**Detroit Metropolitan Credit Union, JSP12-69**

Consideration of the request of Stucky Vitale Architects for a recommendation to City Council regarding the Preliminary Site Plan. The subject property is located in Section 23 at the northeast corner of the intersection of Main Street and Novi Road in the TC-1, Town Center District. The development area is 0.83 acres and the applicant has proposed a second story on the previously approved Detroit Metropolitan Credit Union.

# PLAN REVIEW CENTER REPORT

Revised Preliminary Site Plan

**ARCHITECTURAL SITE PLAN - PRELIMINARY**

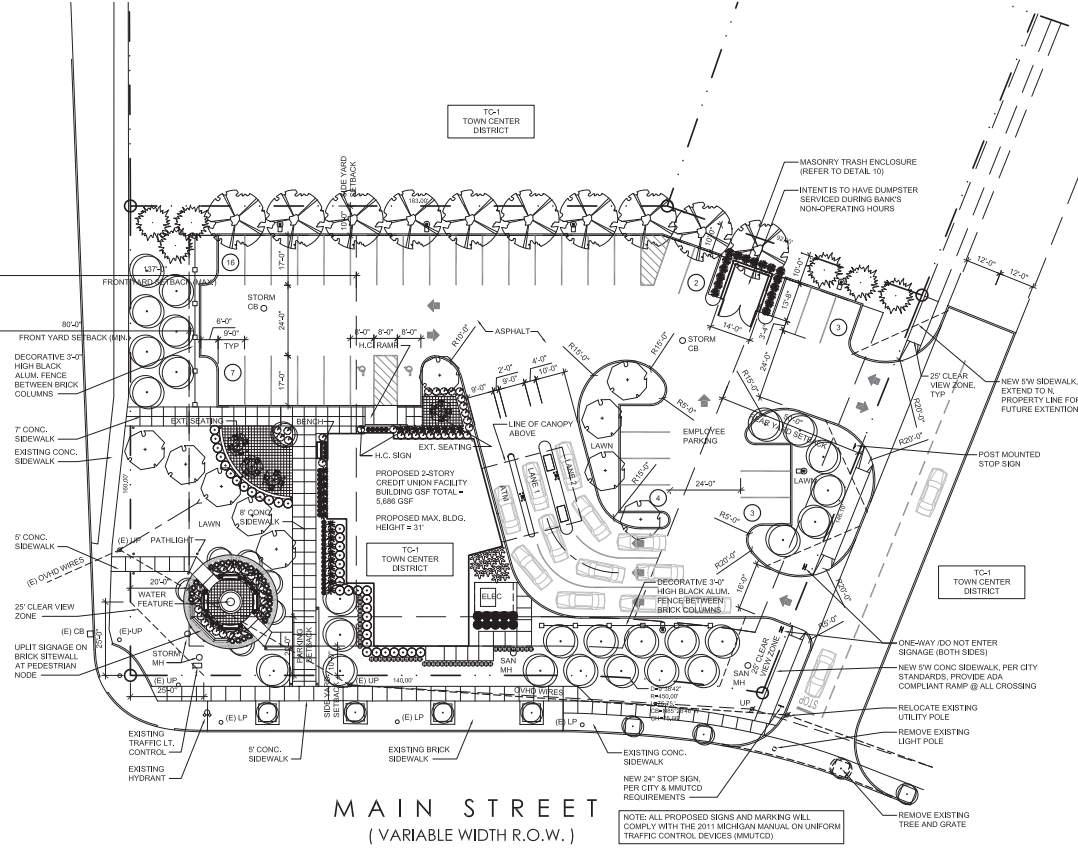
1. Second Floor Use: The applicant previously indicated the second floor use as 'community space' to be used as an accessory use to the proposed credit union. Per the letter submitted on April 14, 2014, the applicant has revised this use from 'community space' to 'conference facility' to be used by credit union staff only for business meetings, etc. As such, for purposes of parking, an office designation has been applied to the second floor space. **The applicant should revise the nomenclature on the upper level floor plan to indicate the office/conference use by credit union employees only in future submittals.**

2. Minor Items: There are minor items noted in the planning review chart and lighting review chart. **The applicant should adjust the plans accordingly for the Final Site Plan submittal.**

5. Shared Access Drive: The main entrance to the subject property is accessed via a shared drive to be located on a parcel separate from the subject property and terminating 175 feet north of Main St. **The applicant should provide additional information regarding where the shared drive will lead or where it will connect to existing drives and buildings and future development sites.**

15. Verify that the proposed feature at the corner of Novi Rd. and Main Street does not conflict with the underground detention system. The applicant must also demonstrate that the underground detention system is capable of carrying the load imposed by the proposed feature.

16. Revise the composite 'c' factor calculation to ' $26,227/38,637=0.68$ ' from ' $38,637/26,227=0.68$ ' as shown.

8. The drive widths are now satisfactory, but **the 10-ft internal curb radius at the south driveway should be increased to provide a smoother entry path for the ATM drive-through lane. This may require enlarging the northerly island slightly to avoid widening the drive beyond 16 ft.**

Vicinity Aerial Photo for Proposed Detroit Metropolitan Credit Union

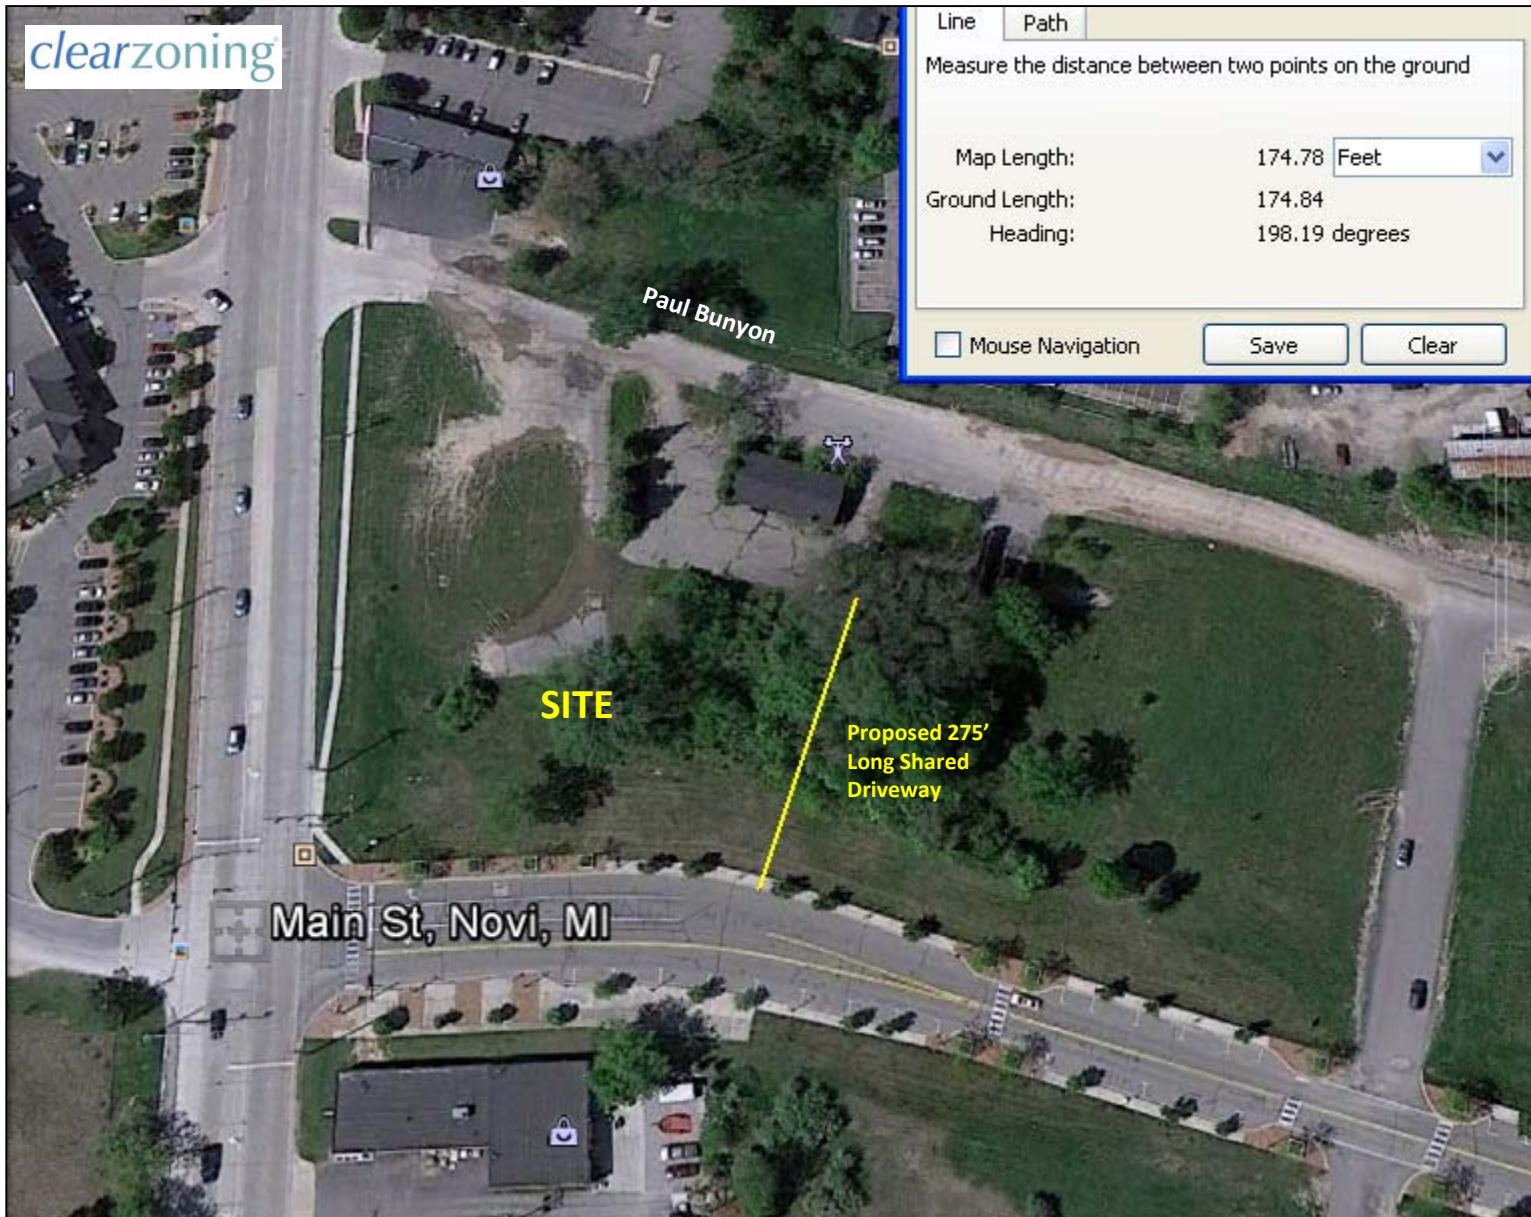
6. The proposed shared driveway would end 175 ft north of the north curb of Main Street. As shown on our attached aerial, this would end that driveway just a few feet short of existing pavement that connects to Paul Bunyon. Since we first raised this issue, the applicant has indicated that “the road will be barricaded.” The curb now proposed at the end of this drive would not, by itself, constitute “effective barricading” (to quote part of our earlier letter). **The final site plan should propose, per page 605a of the 2011 Michigan Manual on Uniform Traffic Control Devices (MMUTCD), a Type 3 barricade for “total closure,” mounted on wood posts embedded in the ground a short distance behind the proposed curb.**
